Proposed NYISO Installed Capacity Demand Curves for the 2021-2022 Capability Year and Annual Update Methodology and Inputs for the 2022-2023, 2023-2024, 2024-2025 Capability Years

A Report by the
New York Independent System Operator

DRAFT REPORT: August 2020

Figure 1: B-Rated Bond Yield, August 2019 to July 2020

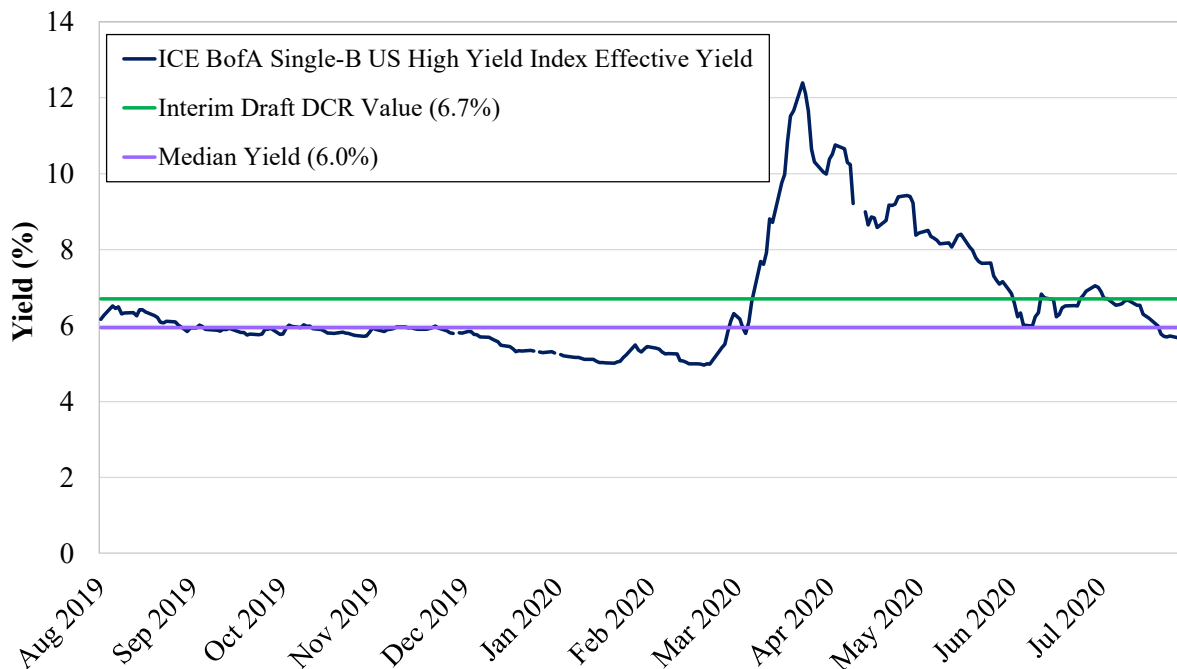
Figure 1 shows that yields began to rise sharply in late February and remained elevated in April and May. These substantial increases reflected severe liquidity issues in the credit markets that have not been sustained. When presenting their rationale for a higher cost of debt in May 2020,

the consultants pointed to the sharp increase in debt costs that occurred between March and April. In particular, the consultants highlighted costs of B-rated debt at 12.4 percent on March 23 and 9.3 percent in the week of April 21.² Since May, Figure 1 shows that the B-rated corporate debt benchmark has fallen considerably.³ Yields then fell close to pre-COVID-19 levels in June and have fallen below 6 percent in July.

Figure 2: Cost of Reserves in DCR Model vs. Historical Average DA Reserve Offers

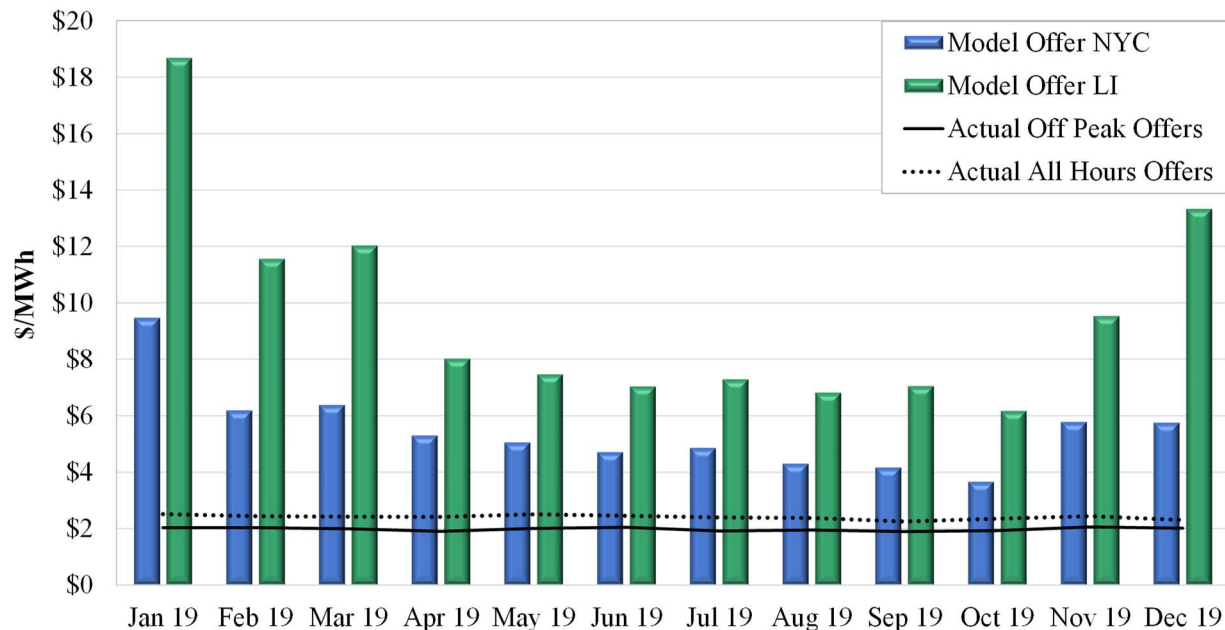
Figure 2 shows that the capacity-weighted average reserve offer was \$2.0/MWh during off-peak hours, when offers are likely to be more competitive, and \$2.4/MWh in all hours. Typical reserve offers had little variation across months. By contrast, the current model methodology implies an average cost of \$6/MWh in Load Zone J and \$9/MWh in Load Zone K in 2019, with monthly averages as high as \$9 in Load Zone J and \$18/MWh in Load Zone K.

Based on this data, we recommend that the consultants replace the fuel-based cost of selling reserves in the day-ahead market with a constant cost of \$2.0/MWh. This will align the modeled cost with typical offer prices for similar existing units in New York. Failing to make this adjustment will lead to unrealistically low reserve schedules and net revenues, especially in Load Zones J and K. Table 5 shows the effects of implementing this recommendation.⁹

Figure 4: Operational Available Capacity on Algonquin Millennium Mainline Segment

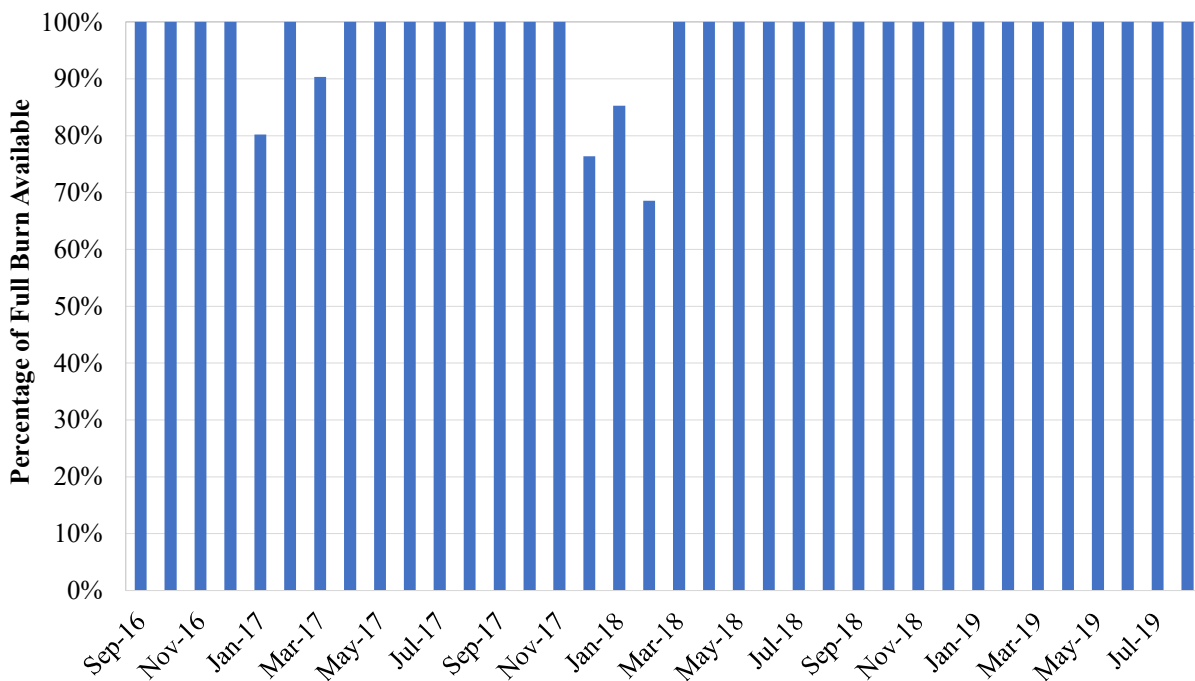
Figure 4 shows the average daily operational available capacity on the Algonquin pipeline segment passing through the Millennium Mainline station in Ramapo, NY as a percentage of the daily gas that would be required for the peaking plant to operate for 24 hours (approximately 75,000 Dth).¹⁵ Average available capacity exceeded the maximum daily burn in most months,

and covered a high percentage of maximum daily burn even in cold winter months. This is likely a conservative measure, as a peaking unit typically will not generate for all hours of a day. Furthermore, as noted above, the recommended peaking plant design for Rockland County is dual fuel and, therefore, also has the option to run on oil in the minority of days when gas may not be available.

Hence, we consider the consultants’ use of TETCO M3 plus \$0.27/MMBtu (along with the assumed intraday premium or discount of 10 percent) to be appropriate for the Rockland County unit, while use of the Algonquin Citygate or Iroquois Zone 2 hubs would be inappropriate given the county’s proximity to the TETCO M3 market zone.
